## ADDENDUM NO. 1

PROJECT: Saline Area Schools – 2022 Bond Program – MS Rec Complex  
 DESCRIPTION: Addendum No.1  
 BID PACKAGE RELEASE NUMBER: BP #3

1. ADDENDUM No. 1, November 20<sup>th</sup>, 2024 as issued by Kingscott (Attached)
2. Bid Package T4 Draft Drawings, October 22<sup>nd</sup>, 2024 - Saline Middle School Rex Complex as issued by Barton Malow (For Reference Only)

SHEET NO.  
**C3.5**

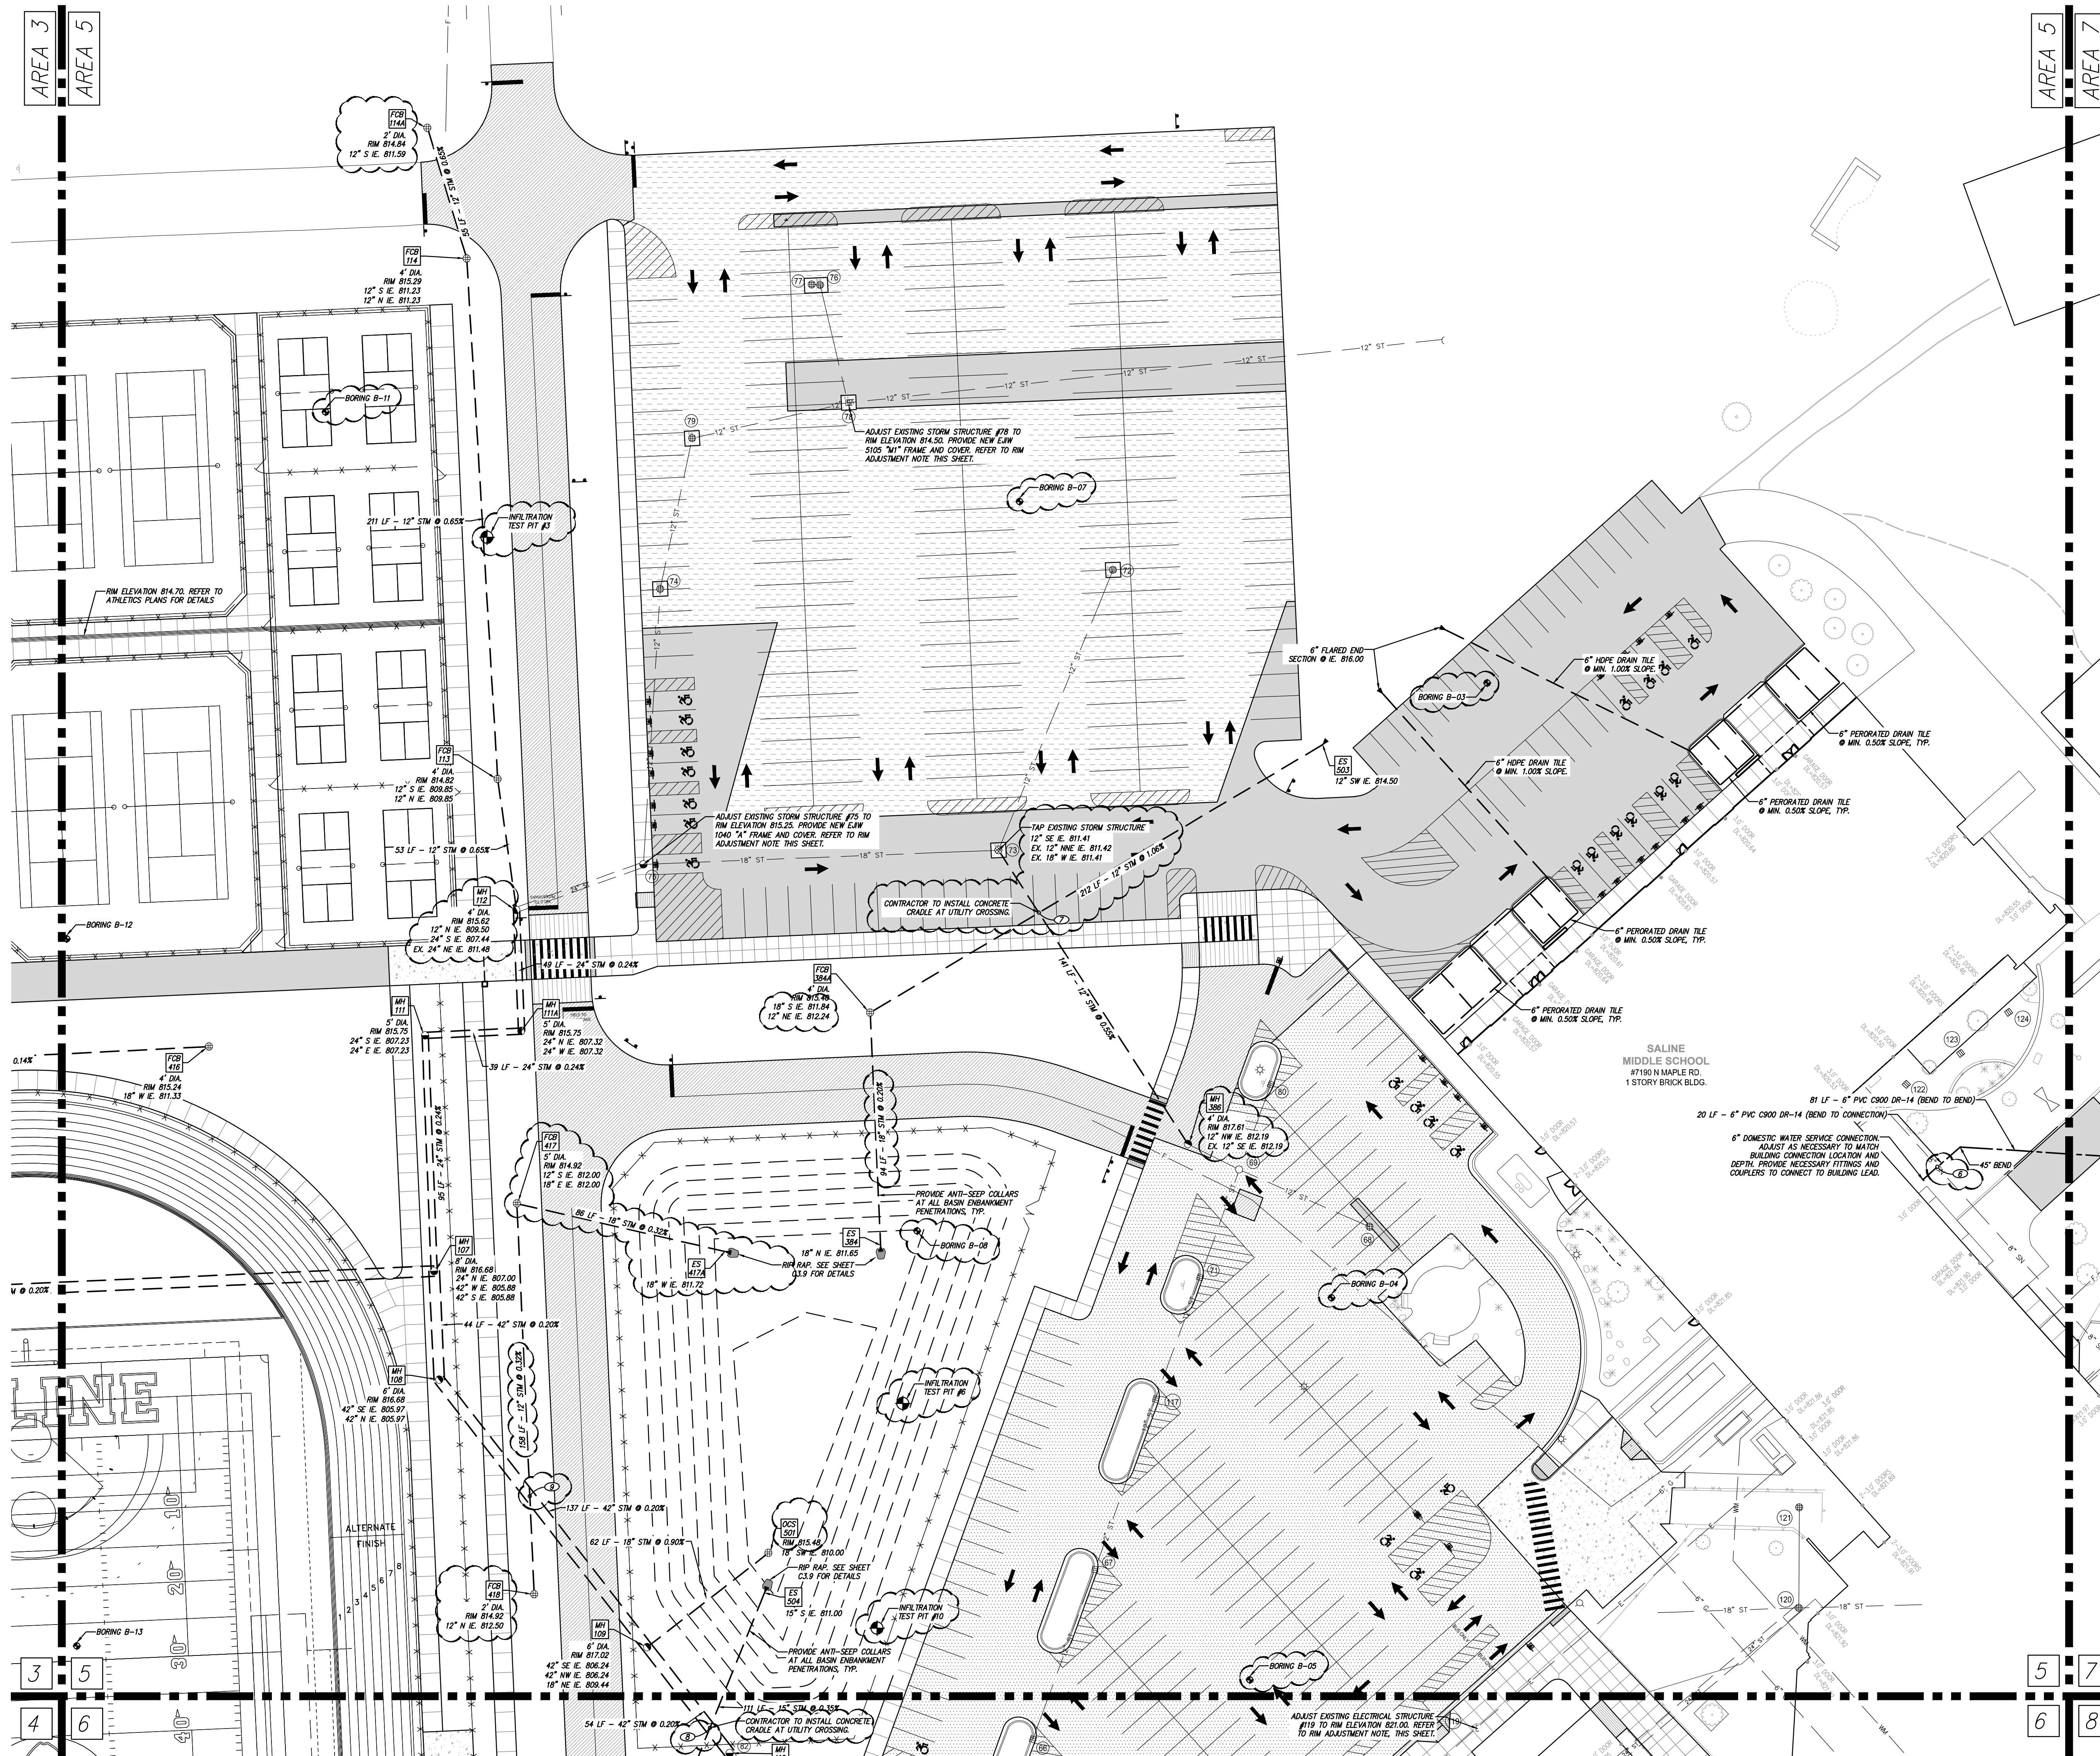
**Item No. 35: Revised inverts, pipe slopes, pipe and structure sizes on sheet C3.5.**

**Item No. 36: Added infiltration test pits on sheet C3.5.**

**Item No. 37: Added boring locations on sheet C3.5.**

**Item No. 38: Added utility crossing number(s) and crossing table(s) on sheet C3.5.**

**Item No. 39: Removed 18" pipe between FCB 417 and FCB 416 on sheet C3.5.**

**Item No. 40: Added 18" pipe from FCB 417 to ES 417A on sheet C3.5.**

**Item No. 41: Revised rim elevation for standpipe on sheet C3.5.**

SHEET NO.  
**C3.6**

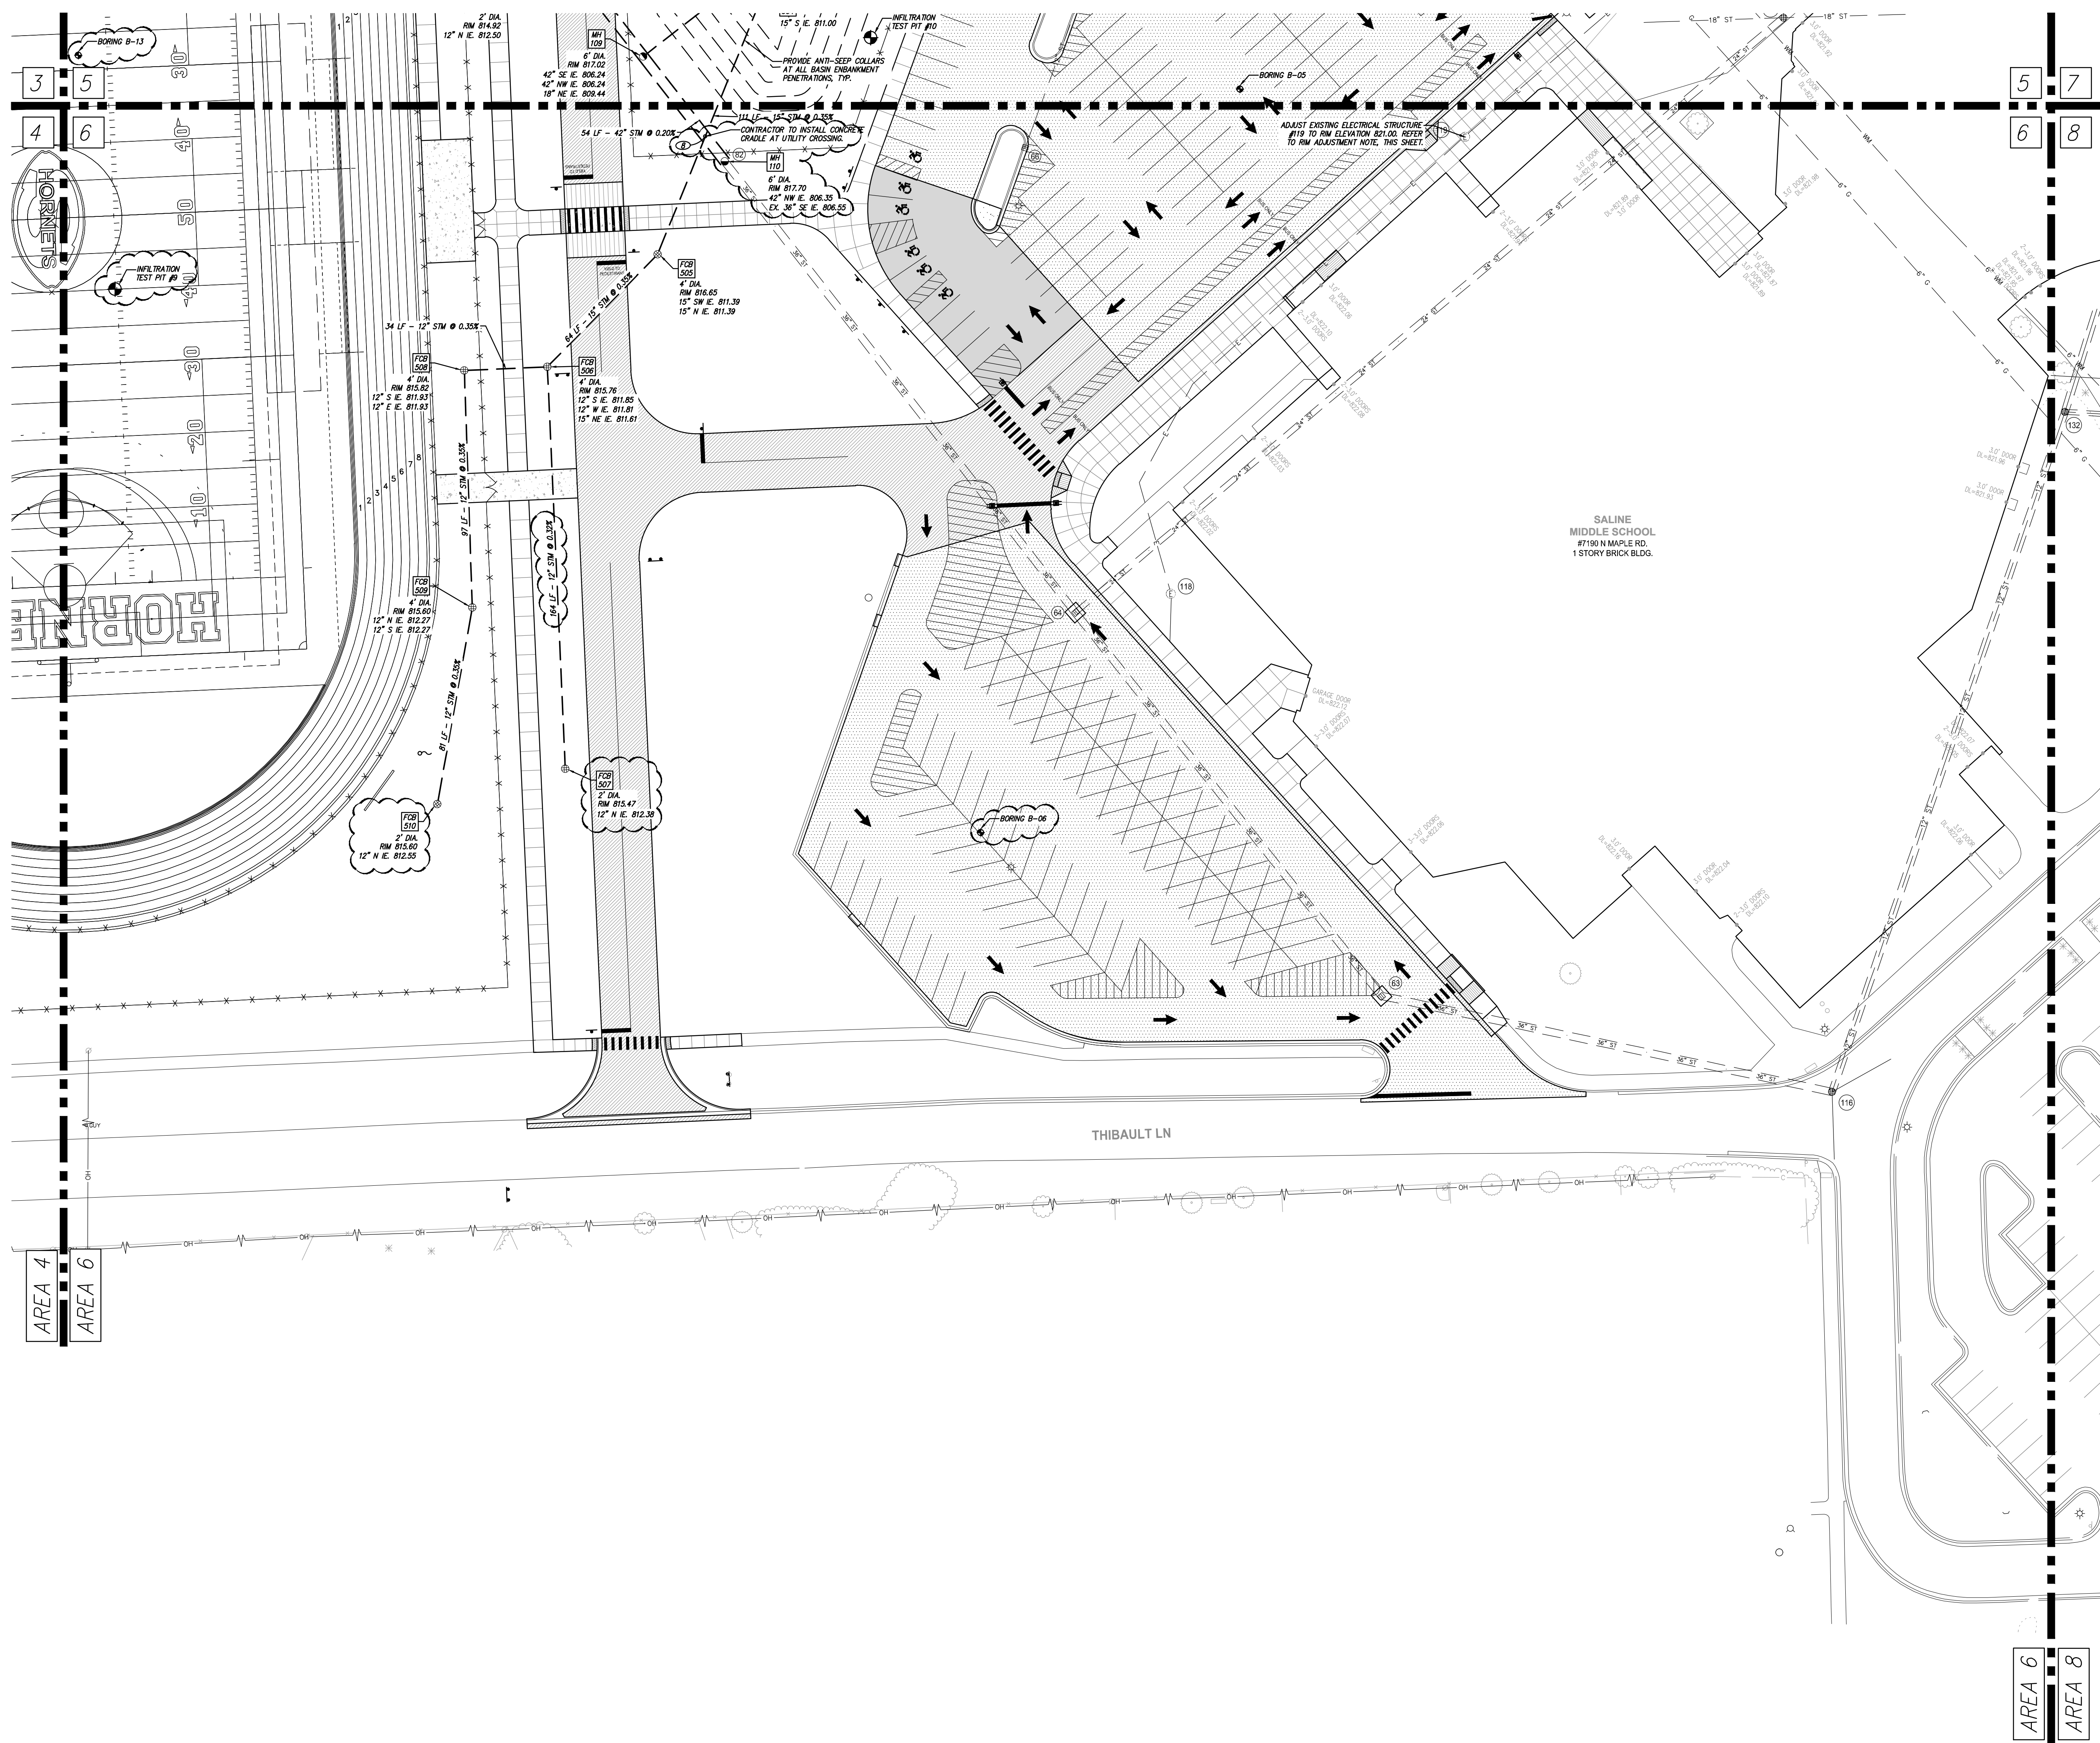
**Item No. 42: Revised inverts, pipe slopes and pipe sizes on sheet C3.6.**

**Item No. 43: Added infiltration test pits on sheet C3.6.**

**Item No. 44: Added boring locations on sheet C3.6.**

**Item No. 45: Added utility crossing number(s) and crossing table(s) on sheet C3.6.**

**Item No. 46: Added concrete cradle note(s) on sheet C3.6.**
